Product Change Notification

| Date Issued : | March 02, 2026 | PCN Number : | 517489 |
| Description of Change : | This notification is to inform about manufacturing process, raw material, and production location for the 505431 Series will move from Molex Japan to Molex Malaysia to stabilize metal supply. Minor appearance differences may occur (gold plating area, pilot hole, trademark marking) with no impact to fit or function. No changes will be made to product as part of this change and only minor change on plating. | | |

Product Appearance Change

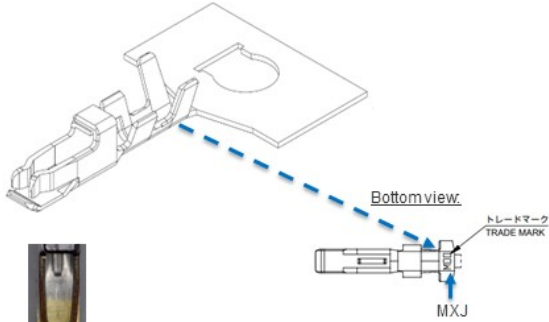
Before

Overview:

- Existing terminal
- Trademark logo marking = MXJ

After

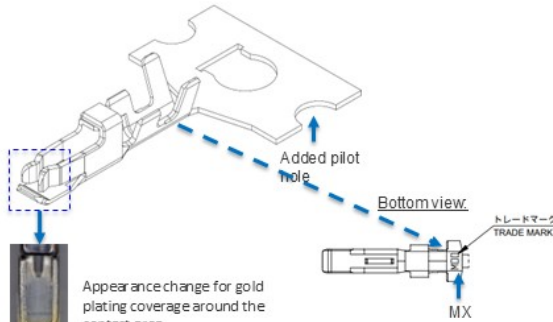
Overview:

- Appearance change for gold plating coverage around the contact area
- Additional pilot hole on carrier
- Trademark logo marking = MX

Appearance change for gold plating coverage around the contact area
